MACH Mt Pleasant Optimisation Project SSD 10418

IPC Presentation

July 2022

Michael White BE Mining (Hons),
MBA, GAICD
Local Resident (Wybong)
Community member UHAQAC

Annual PM 2.5 2012-2021

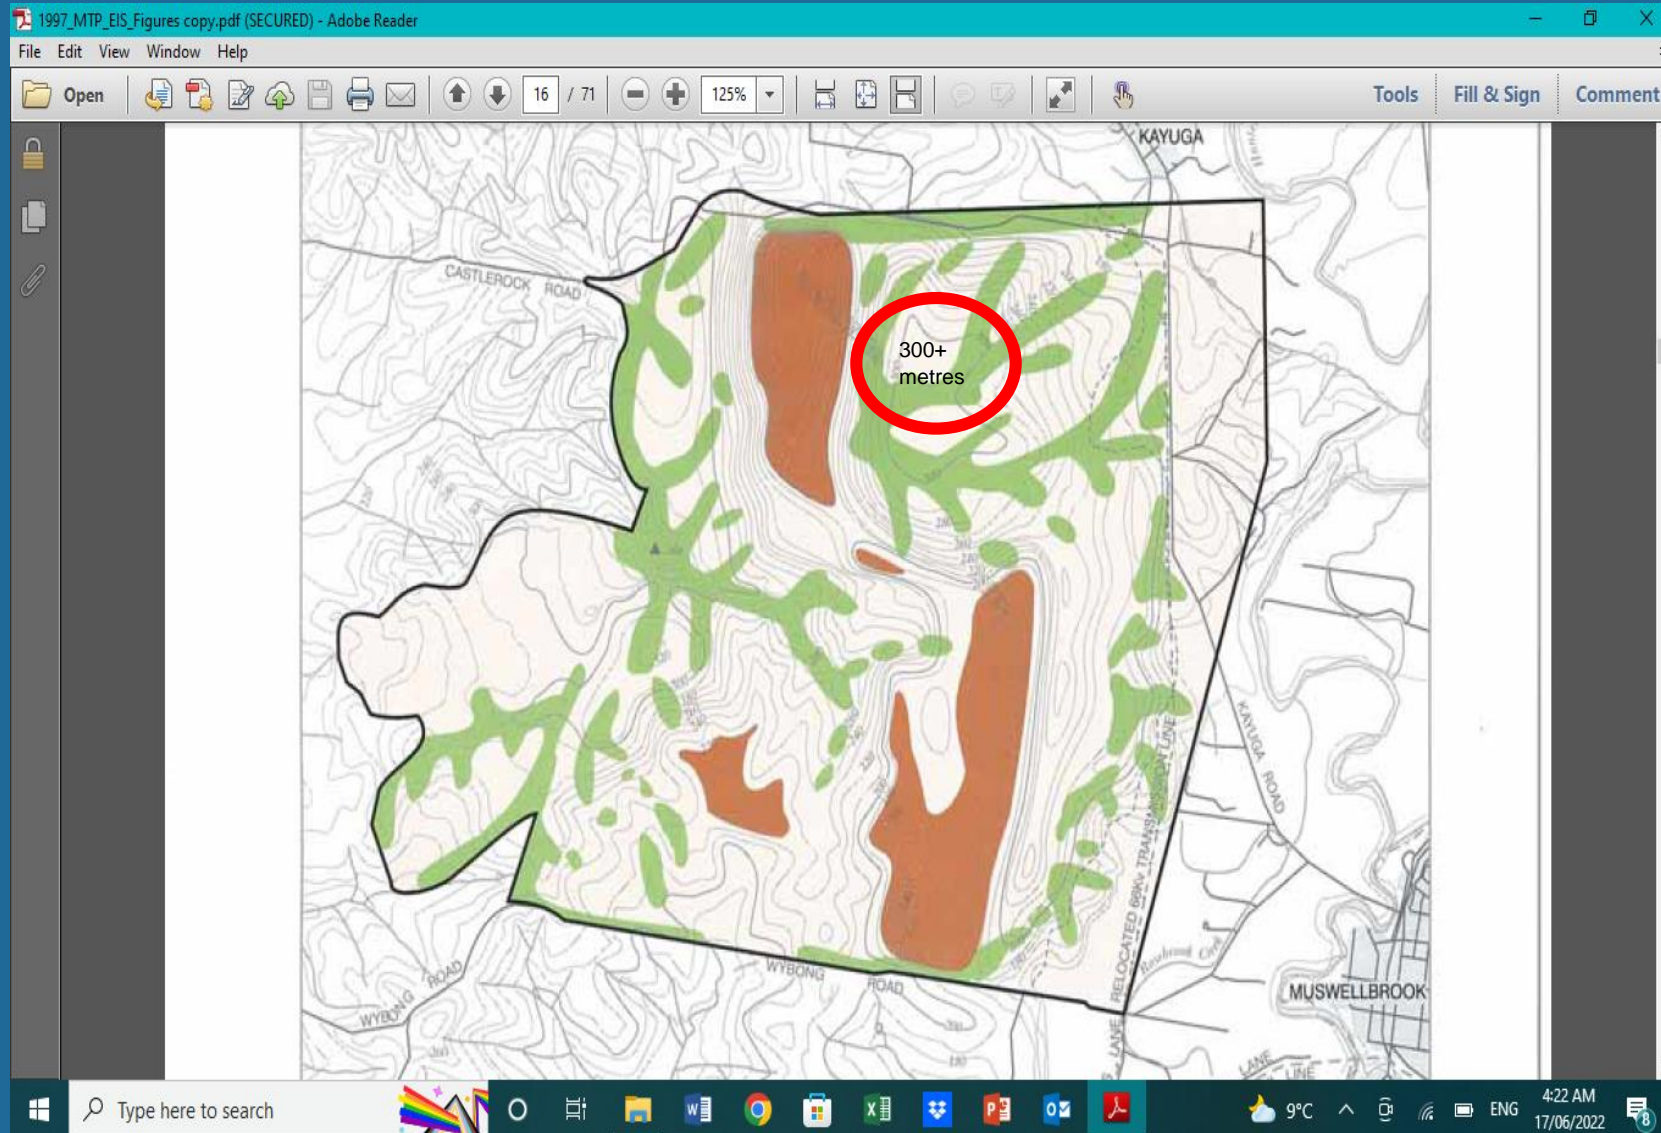
Muswellbrook has exceeded the PM2.5 annual NEPM criteria of 8 $\mu\text{g}/\text{m}^3$ in eight of the last ten years.

The 2021 EA Proposed Final Landform and Final Void

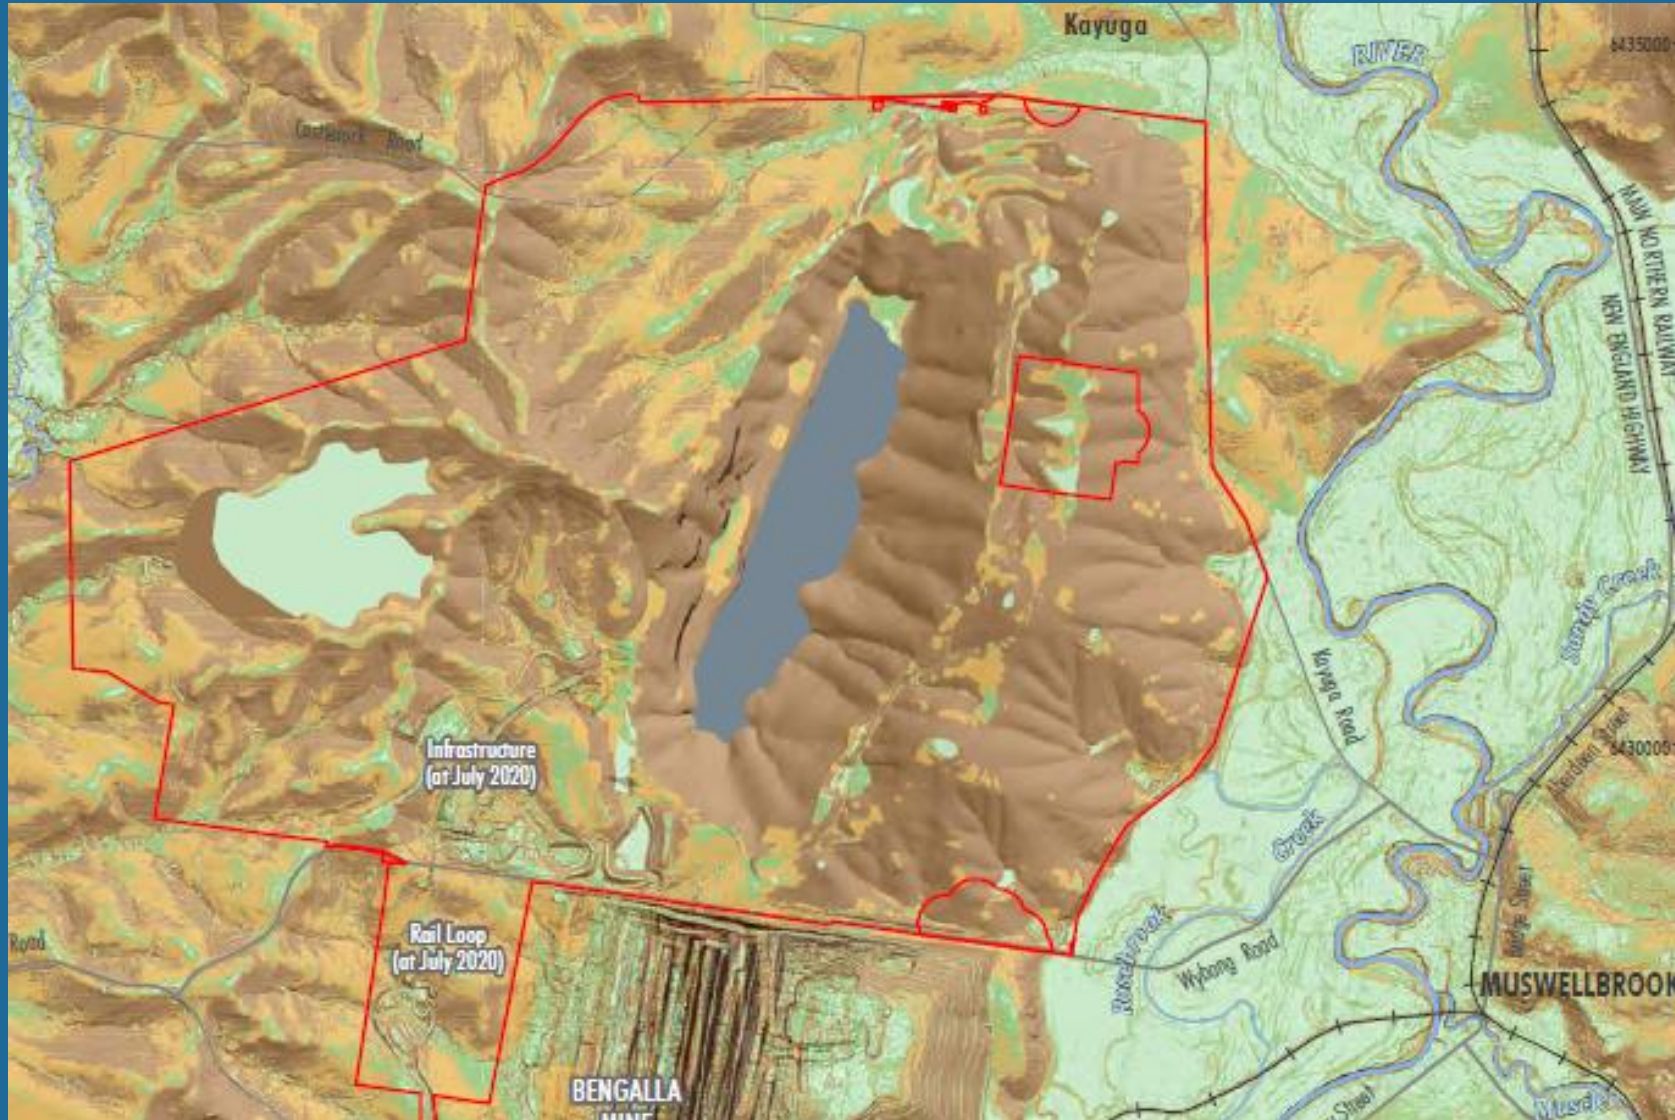
The final landform is a terrible lasting legacy for the Upper Hunter

This Project Proposal

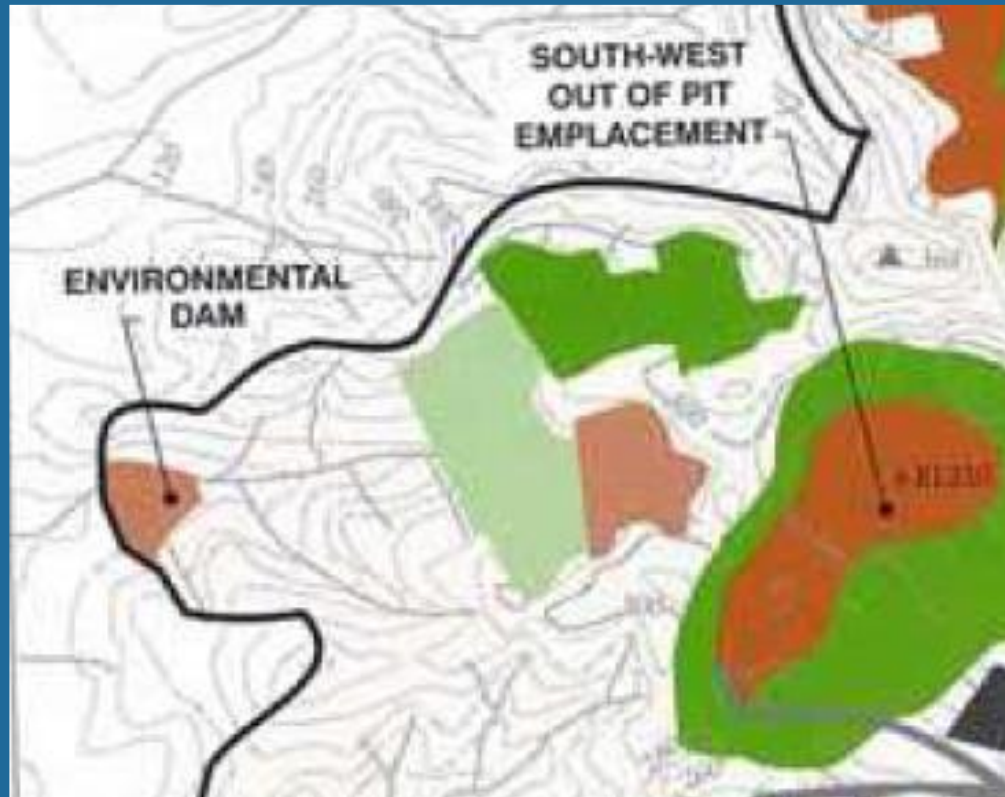
- The Project would require an ultimate doubling in the capacity of the Tailings dam from the currently approved **17.7 million cubic metres to 36 million cubic metres**
- **The Tailings dam wall would be increased in height by 38.9 metres to a height of 69.4 metres** through six additional dam wall raises
- The dam area is significantly increased to **166ha**.

The so-called “contemporary” strategy proposed by MACH and approved by DPE in the MOD3 Consent is a retrograde step and is at odds with the original 1999 approval.

- It does not maximise natural runoff downstream flows.
- It does not minimise the disturbed area footprint of the Fines Emplacement Area
- It does not have a multiple cell arrangement

- It does not seek to blend in with the surrounding topography. There will be one large embankment much higher than the proposed terrace embankments
- It does not allow for early and progressive rehabilitation

- It does not allow for any rehabilitation to occur in the Fines Emplacement Area until several years after mine closure assuming the rejects have dried out sufficiently to allow for capping

Changes to the Fines Rejects Disturbance Area Footprint

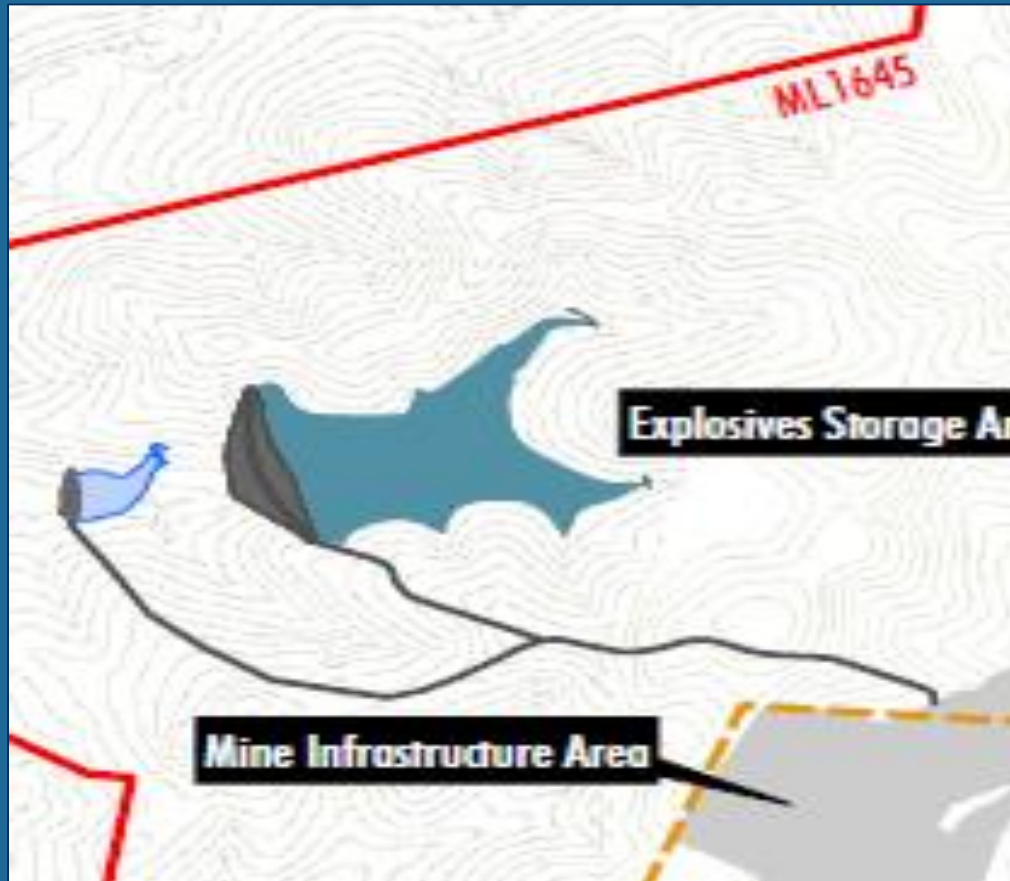
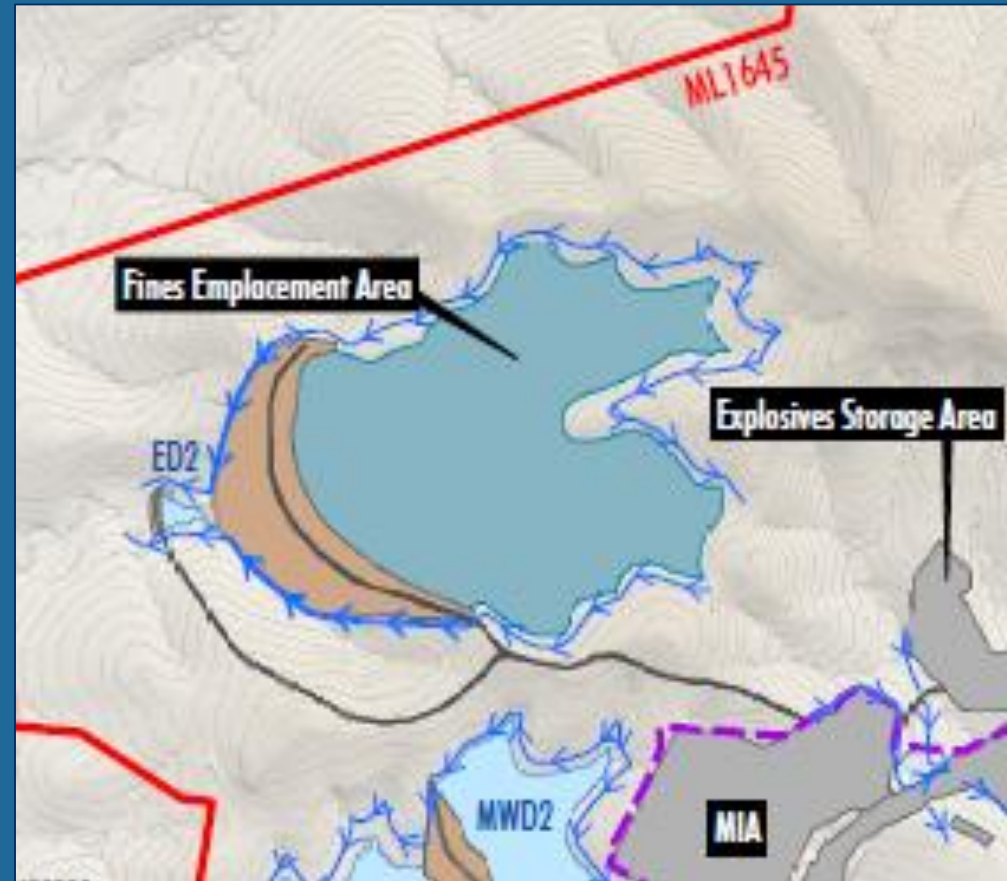
- MACHs statement that the Project proposal fines emplacement area has a smaller disturbance footprint than the original 1997 proposal is misleading because the original proposal included a staged rehabilitation and the progressive return of cells to clean water run-off over the life of the mine.
